From: Vaibhav S <>
Sent: Thursday, July 11, 2024 10:26 AM
To: COA <coa@brampton.ca>; Medeiros, Martin - Councillor <Martin.Medeiros@brampton.ca>; Keenan, Dennis (Councillor) <Dennis.Keenan@brampton.ca>
Subject: [EXTERNAL]Concerns regarding Application A-2024-0109, 227 and 229 Main Street South

Image 6b: Predicted Wind Conditions - Winter

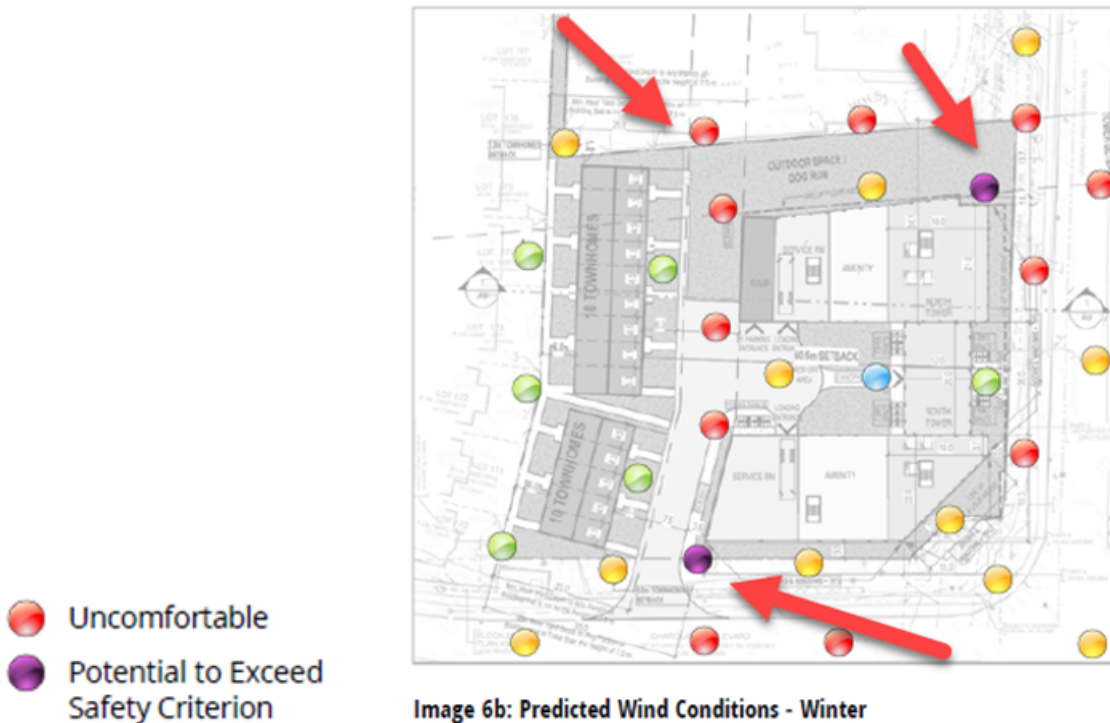
WIND STUDY EXCEEDING SAFETY CRITERION

- Wind conditions in the summer are expected to be acceptable for active uses like walking, at most areas. However, in the winter, wind conditions that exceed the comfort and safety criteria are expected at several areas – particularly near the northeast and southwest corners of the main building due to the seasonal strong winds.
- We recommend the evaluation of the wind impact of the proposed development through wind tunnel testing in order to quantify and confirm the potential wind conditions, and thereby develop appropriate wind control measures.

WIND STUDY

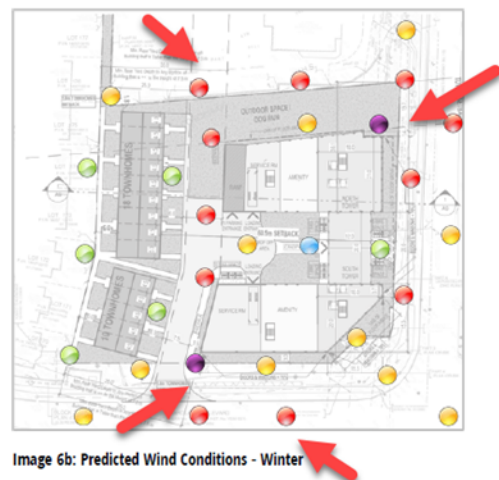
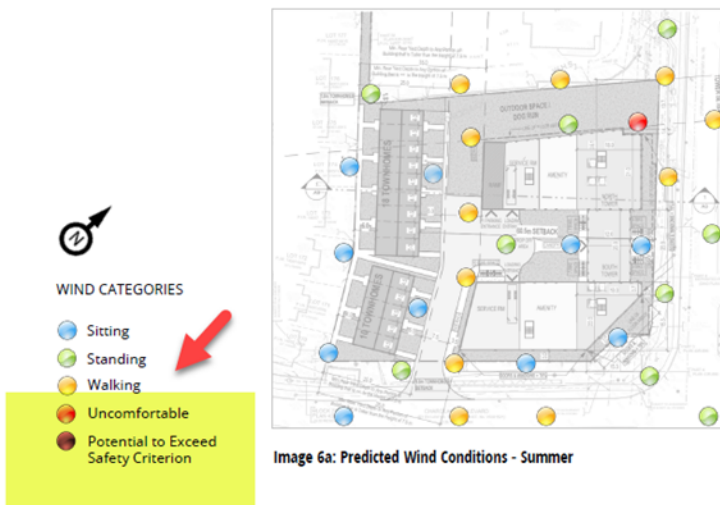
RWDI recommends the consideration of wind control measures to reduce the potential high wind activity. Wind control features may take the form of strategic placement and a combination of additional massing steps/articulations to façade and corners of the podium massing, setbacks on the north and west side of the towers above the first few floors, canopies on the main facades, tall wind screens and evergreen trees/hedges (Image 7).

RWDI can guide the selection and incorporation of wind control measures as the design progresses. We recommend quantifying the wind impact of the proposed development through wind tunnel testing to confirm these predictions and to develop wind control measures.
